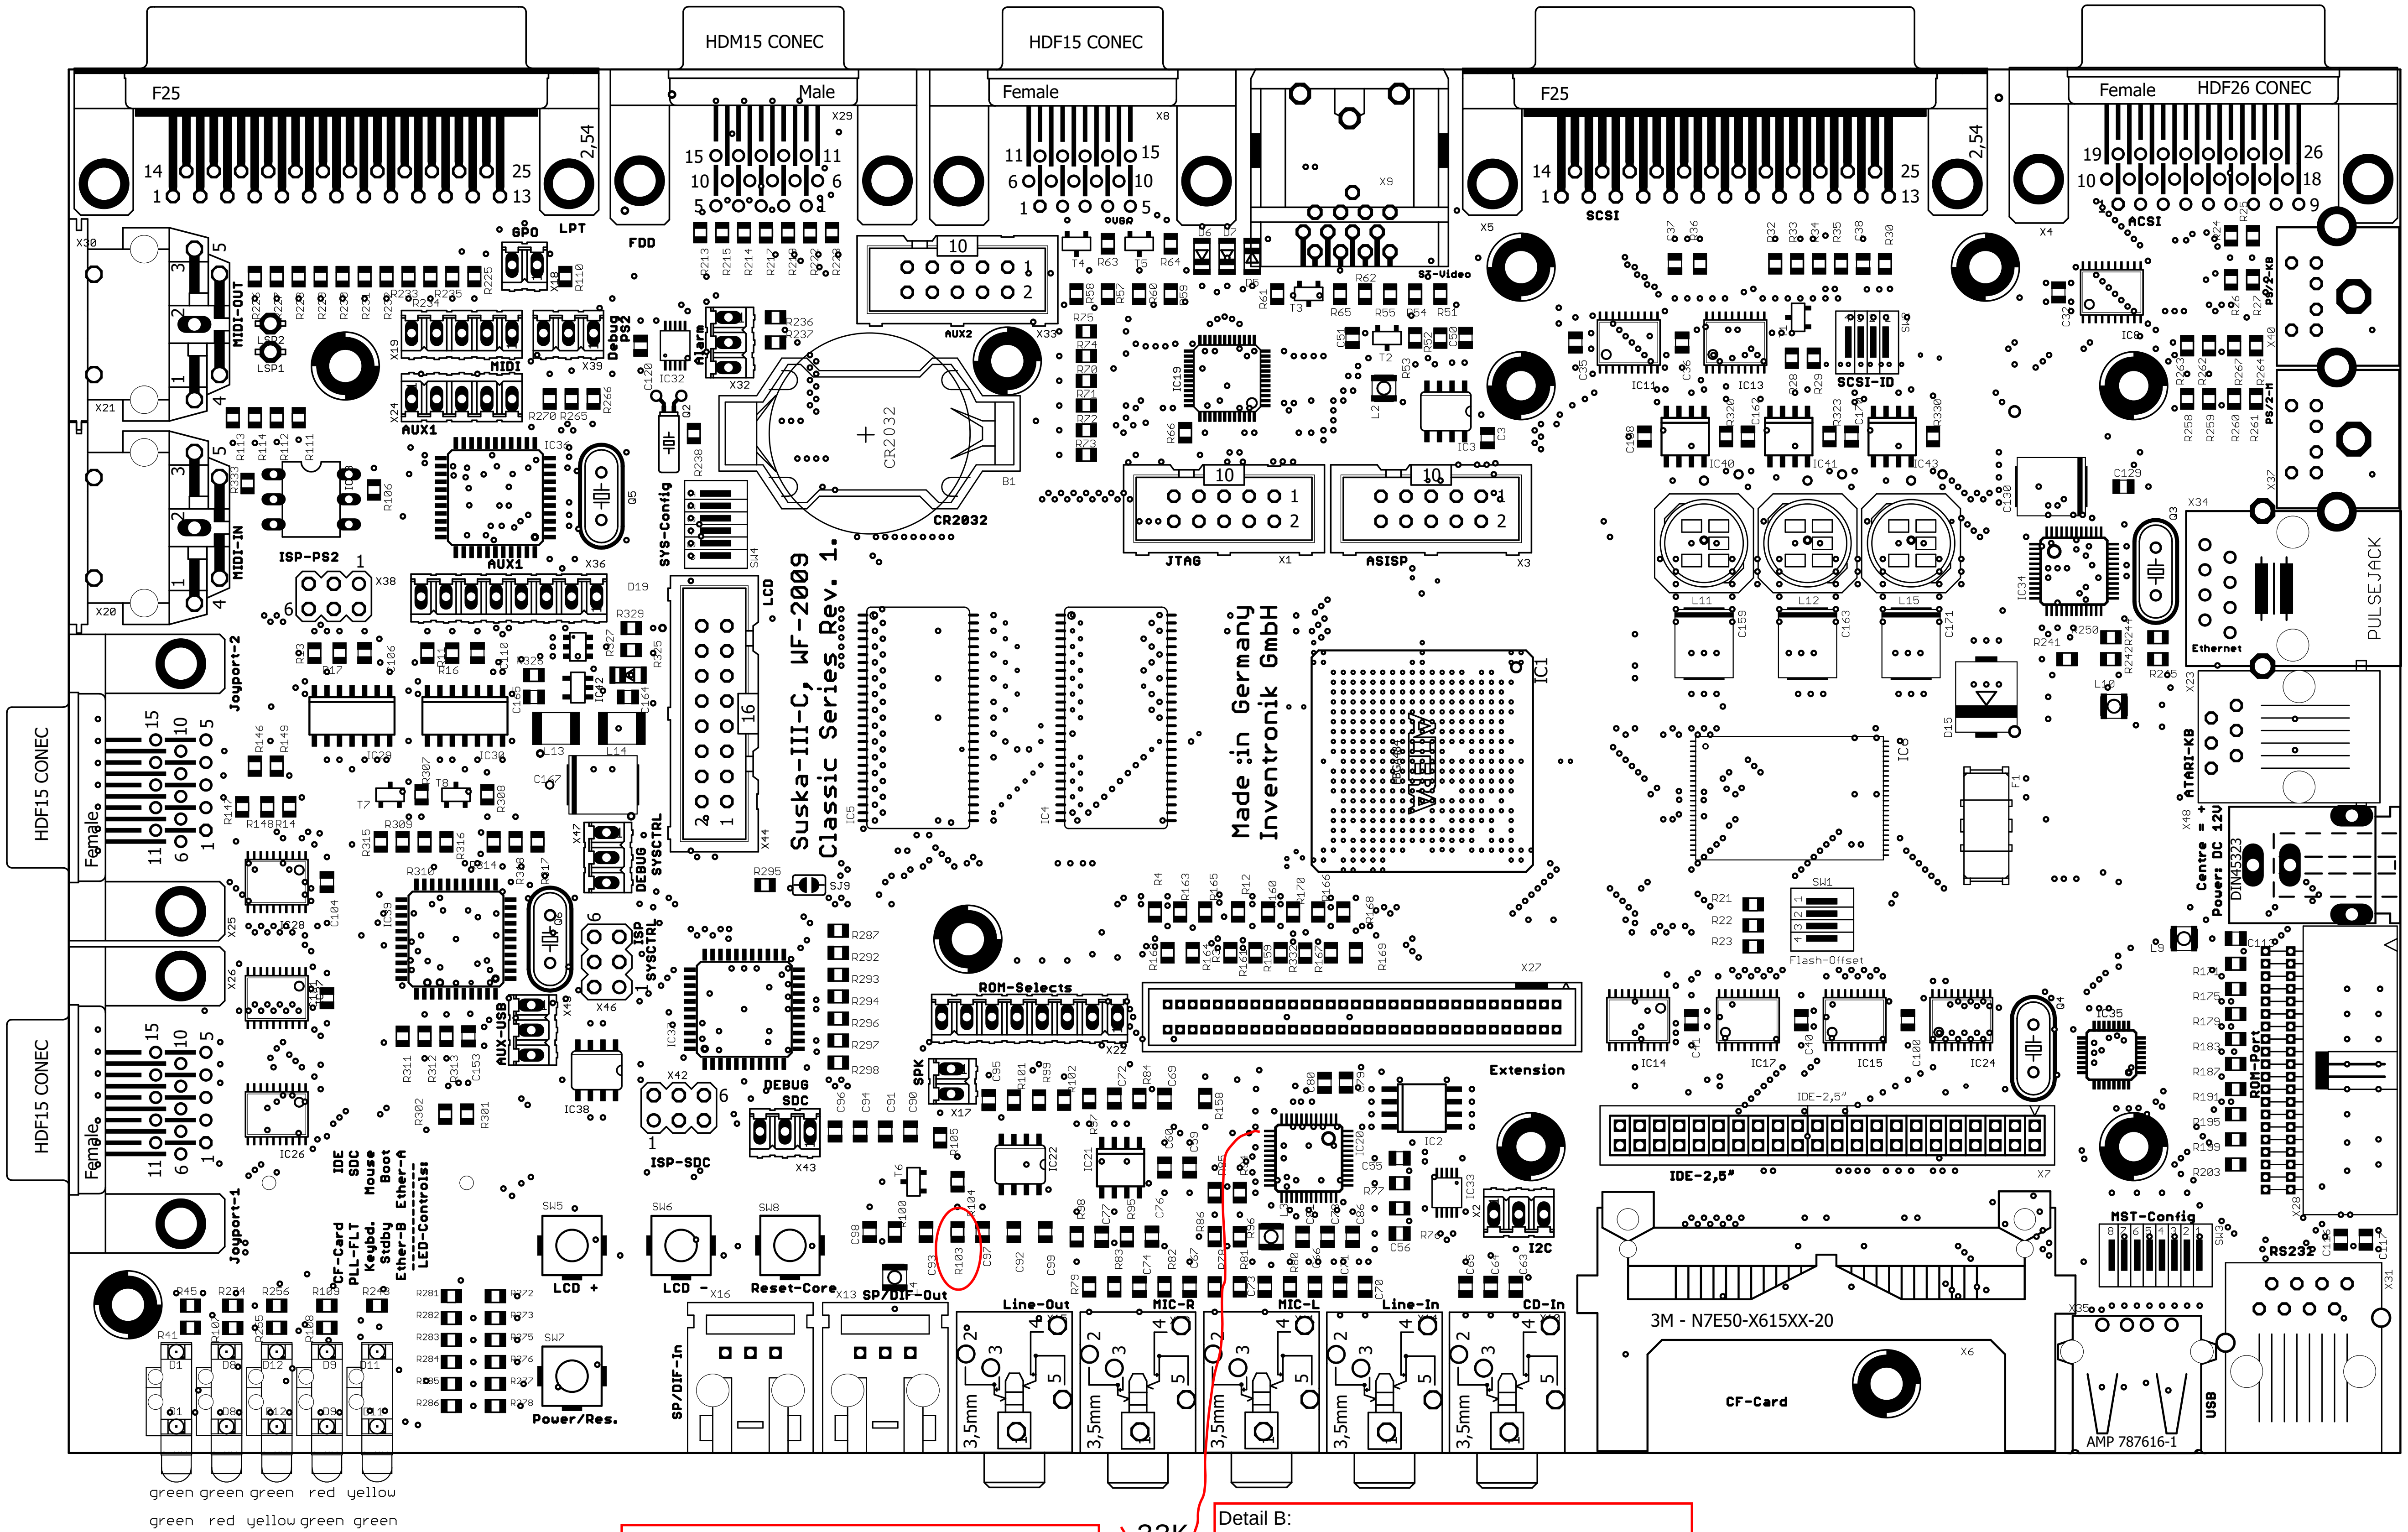
33K
68K

Detail A:
replace R103 by a series connection of a 33K resistor against ground and a 68K resistor against C92.

Detail B:
disconnect pin 13 of the CODEC (IC 20) from the PCB and connect it to the center of the resistors.
